# Memorandum to the City of Markham Committee of Adjustment

**File:** A/17/18  
**Address:** 54 Grandview Avenue, Thornhill  
**Applicant:** Sohrab Khosraviani  
**Agent:** Sohrab Khosraviani  
**Hearing Date:** Wednesday July 25, 2018

The following comments are provided on behalf of the West Team. The applicant is requesting relief from the following requirements of By-law 2237 - R4, as amended:

DRAWING  
SITE PLAN

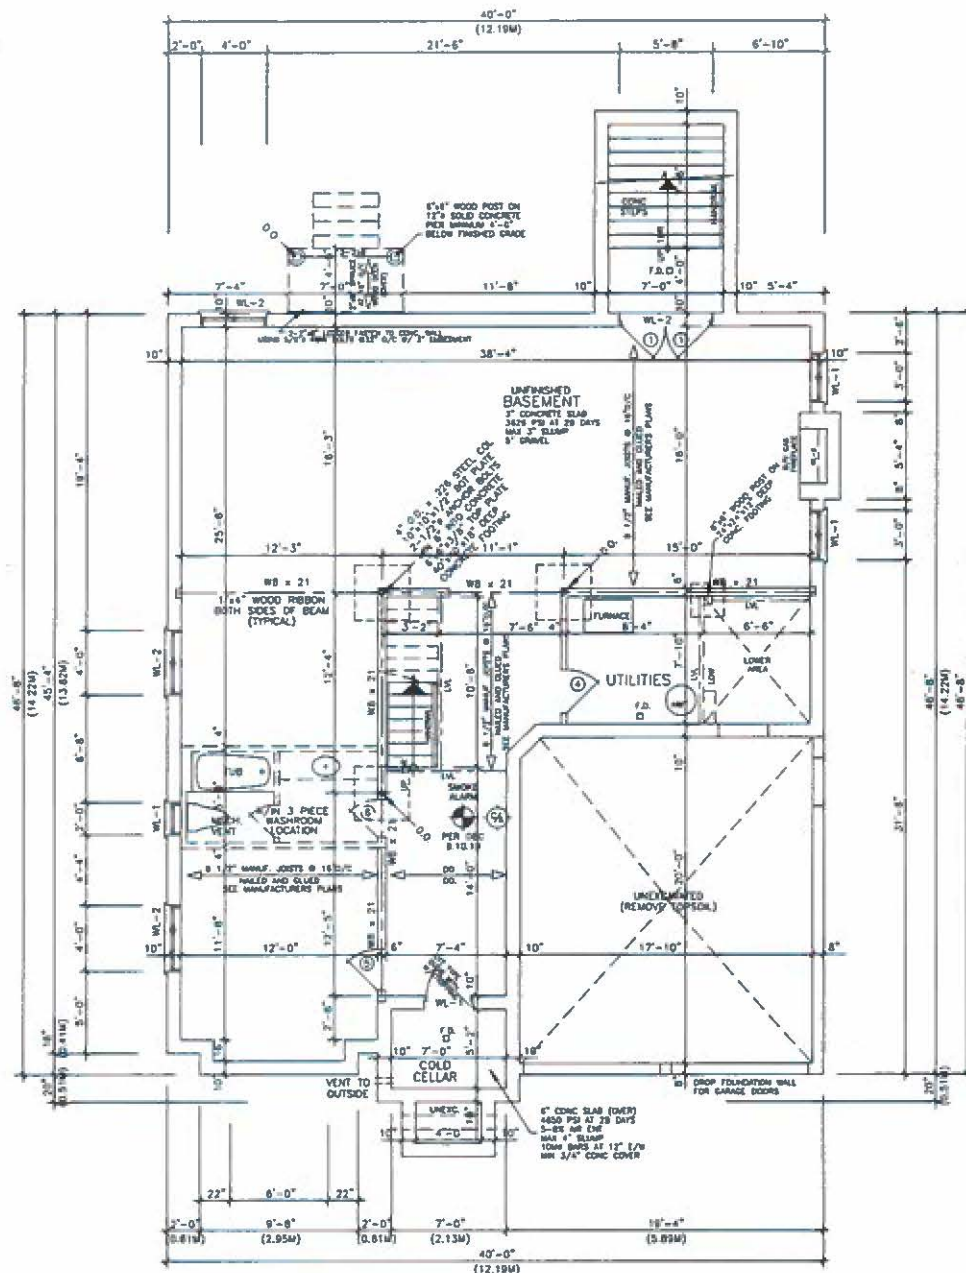
a maximum floor area ratio of 54.79 percent, whereas the by-law permits a maximum floor area ratio of 50 percent;

a minimum interior side yard of 1.52 metres on both sides, whereas the by-law permits a minimum interior side yard setback of 1.8 metres on both sides,

NO.	REVISIONS	DATE
1	REVISED AS PER PLANNING DEPT. COMMENTS	MARCH 9 2018
2	REVISED AS PER PLANNING DEPT. COMMENTS NO. 2	MARCH 28 2018
2	REVISED DWELLING HEIGHT TO 8.58m TO COMPLY WITH ZONING	JUNE 18 2018

DRAWING  
SITE PLAN

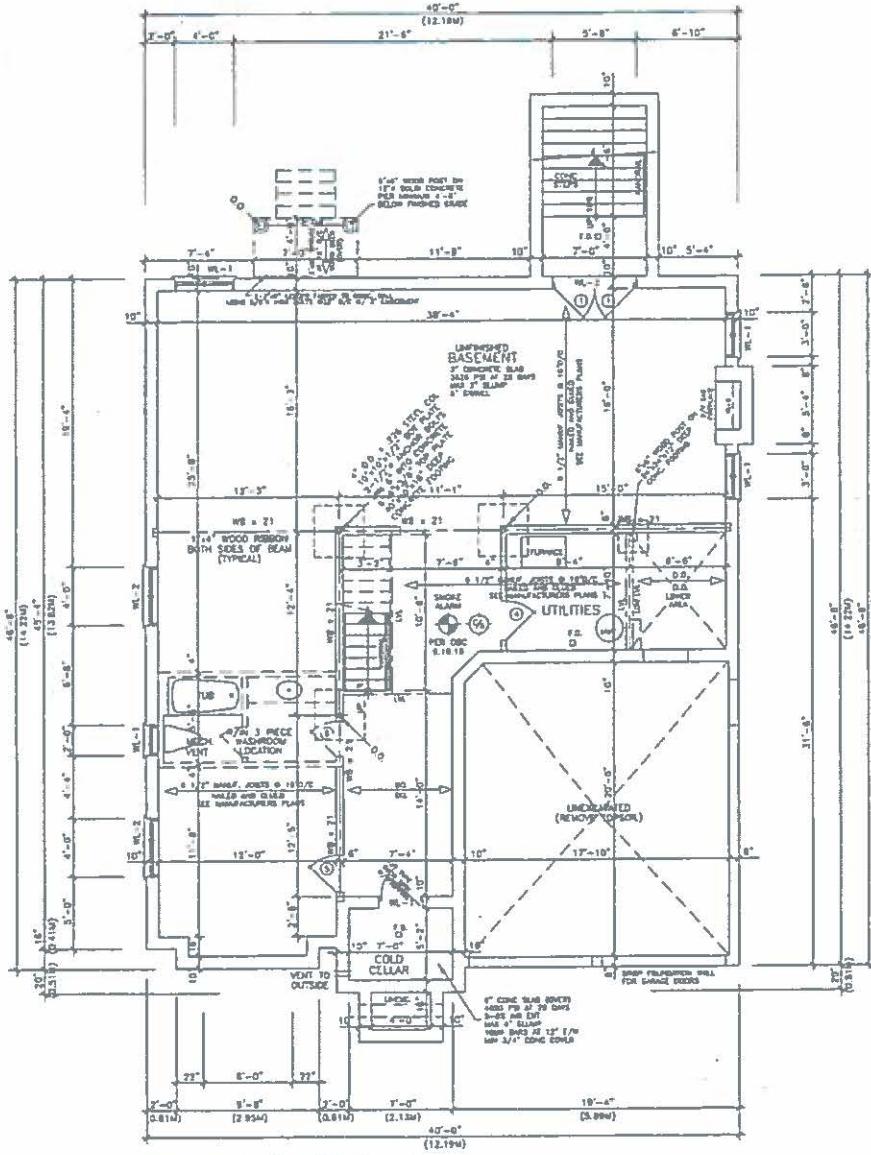
The applicant is requesting relief to permit a maximum building height of 9.04 m (29.65 ft), whereas the By-law permits a maximum building height of 8.6 m (28.21 ft). This represents an increase of 0.44 m (1.44 ft) or approximately 5.1%. There are a number of new infill developments on the street with similar building height, including the new home at 51 Grandview Avenue which obtained a minor variance approval in 2016 for an increased height of 9.61 m (31.52 ft). Staff are of the opinion that the proposed building height is respectful of surrounding built form and consistent with the recent infill development trend in the neighbourhood.

The applicant is requesting relief to permit a maximum Net Floor Area Ratio of 54.79%, whereas the By-law permits a maximum Net Floor Area Ratio of 50%. The proposed increase to the Net Floor Area Ratio will facilitate the construction of a dwelling with a gross floor area of 316.92 m<sup>2</sup> (3,411.3 ft<sup>2</sup>); whereas the By-law permits a dwelling with a maximum gross floor area of 289.12 m<sup>2</sup> (3,112 ft<sup>2</sup>). This represents an increase of 27.8 m<sup>2</sup> (299.23 ft<sup>2</sup>), which is an increase of approximately 9.6%.

The applicant is requesting a minimum west and east side yard setback of 1.52 m (4.98 ft) for the two-storey portion of the dwelling, whereas the by-law requires a minimum side yard setback of 1.8 m (5.9 ft) for the two-storey portion of the dwelling. This represents a reduction of 0.28 m (0.91 ft) or approximately 15.5 percent. The variance only applies to the second floor of the building. The ground floor component meets the minimum setback requirement meaning sufficient room will be provided between adjacent homes for access and drainage.
